Subject: FW: RB2 Review of Parcel E-2 Draft Final Phase II RACR

For your review and distribution, please find the updated Response to Comments (RTC) file to the Draft Final Remedial Action Completion Report, Parcel E-2 Phase II.

Response to Comments on the Draft *[Final]* Remedial Action Completion Report, Parcel E-2 Phase II, Hunters Point Naval Shipyard, San Francisco, California, June 2020, DCN: APTM-2005-0013-0047

*Comments by: Jeff White, San Francisco Bay Regional Water Quality Control Board, comments dated March 6, 2020; **follow-up on August 7, 2020***

FIGURE 7
TIDAL WETLAND FINAL CHEMICAL
CONFIRMATION SAMPLE GRIDS

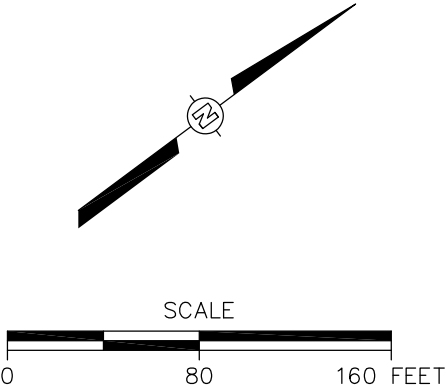
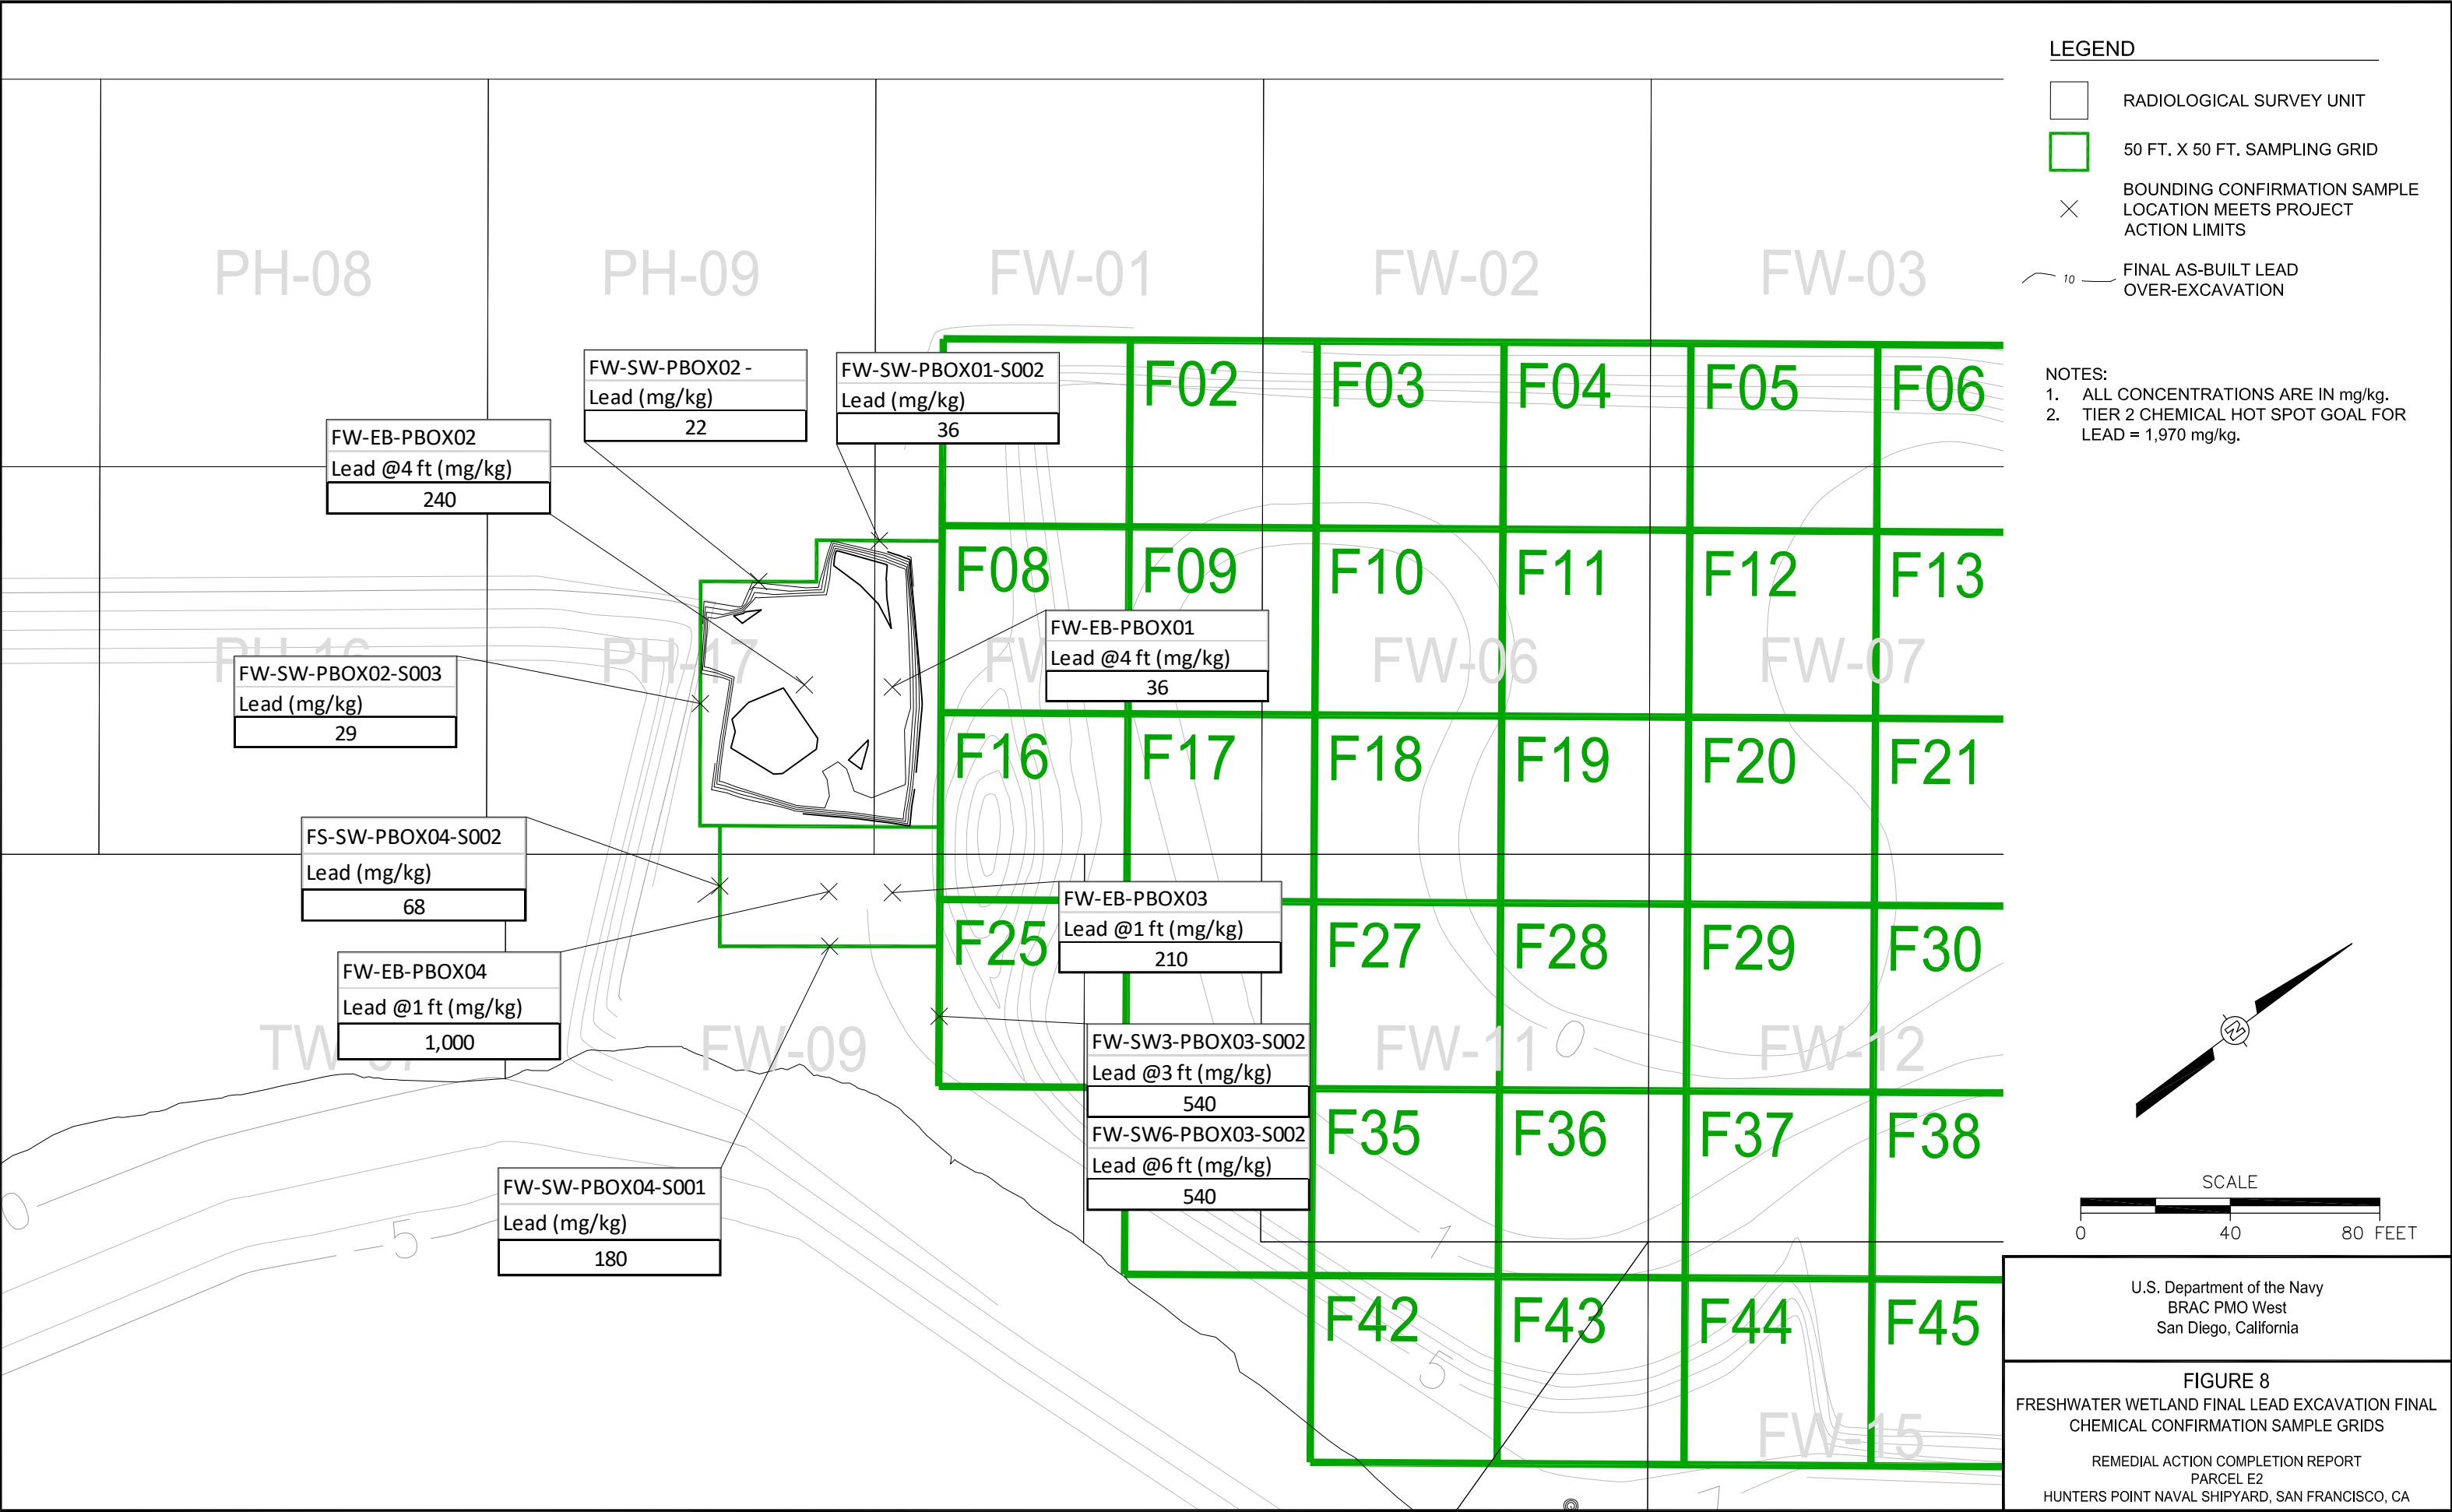
10. Figure 7 Tidal Wetland Final Chemical Confirmation Sample Grids

For clarity, the following notes have been added to Figure 7.

- a) Results shown in **red** indicate samples exceeding the project action limit.
- b) Consistent with Figure 6, hot spot goals for Cu, TPH, and PCBs have been added to the Legend.
- c) The CAD layer showing the additional sample locations was inadvertently turned off. This oversight has been corrected.
- d) Consistent with the changes made to Figure 6; a list of abbreviations has also been added to Figure 7 to include:
T – Tidal Wetlands Confirmation Sample
EB – Excavation Bottom Confirmation Sample
SW – Excavation Sidewall Confirmation Sample
N – North
E – East
S – South
W – West
Mg/kg – milligram per kilogram
Pb – Lead
PCB – Polychlorinated Biphenyl
TPH – Total Petroleum Hydrocarbons
Cu – Copper
